ORIGINATION FORM

Proposed Revisions to a Standard Plans Index

Index Number: 455-154
Sheet Number (s): 1
Index Title: 54" Precast/Post-Tensioned CFRP & SS
Concrete Cylinder Pile

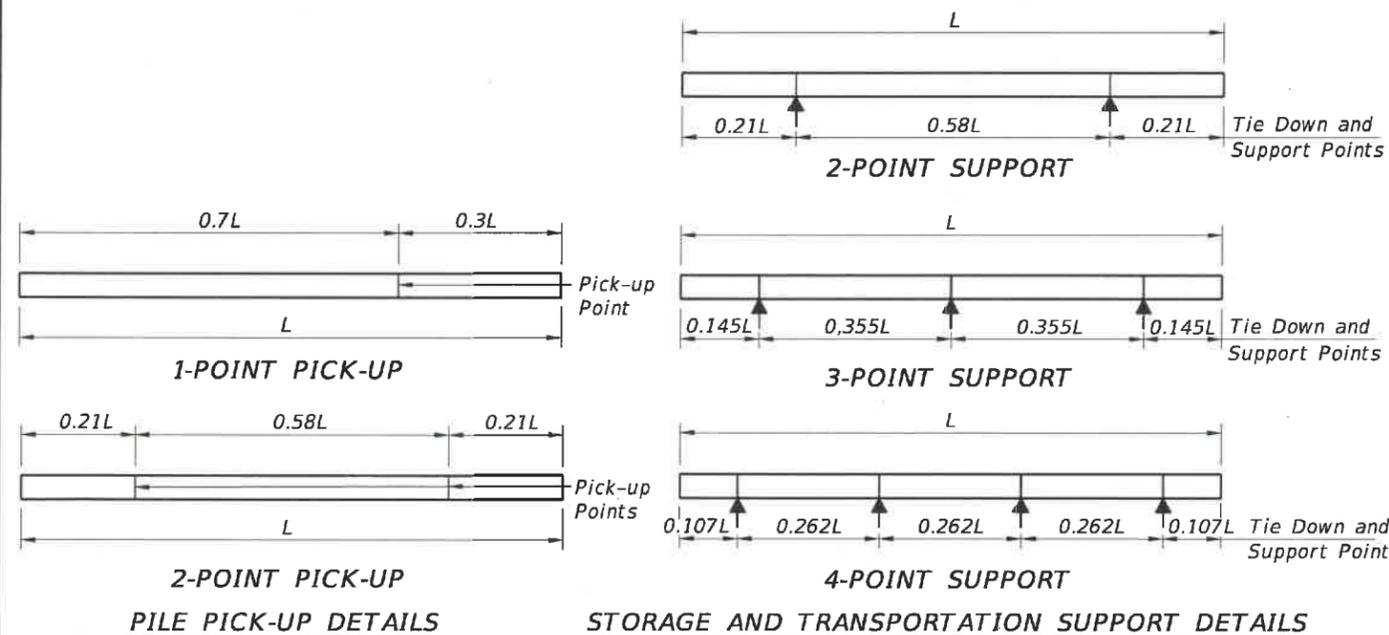
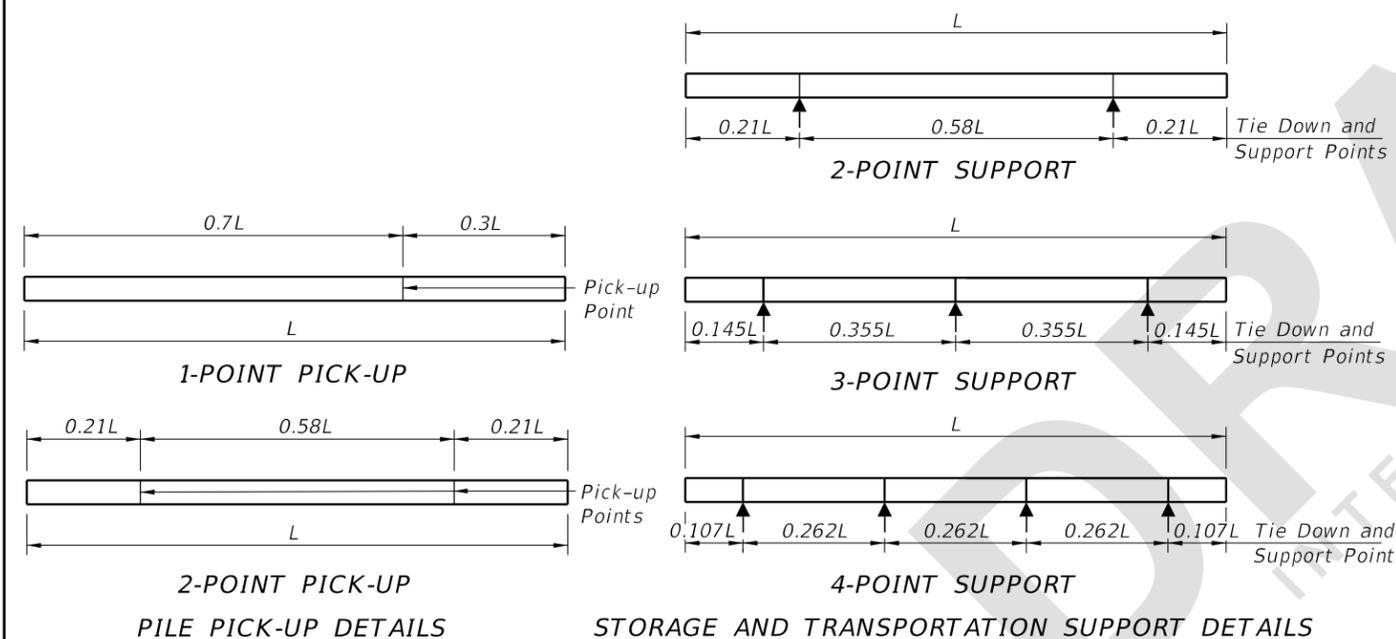
Changed Class V (Special) concrete to Class V.

- Work this Index with the Pile Data Table in the Structures Plans.
- Concrete:
 - Piles: ~~Class V (Special)~~
 - Splice: ~~Class IV~~
 - See "GENERAL NOTES" in Structures Plans for locations where the use of Highly Reactive Pozzolans is required for options using stainless steel strand and reinforcing.

1. Work this Index with the Pile Data Table in the Structures Plans.
2. Concrete:
 - A. Piles: Class V
 - B. Splice: Class IV
 - C. See "GENERAL NOTES" in Structures Plans for locations where the use of Highly Reactive Pozzolans is required for options using stainless steel strand and reinforcing.
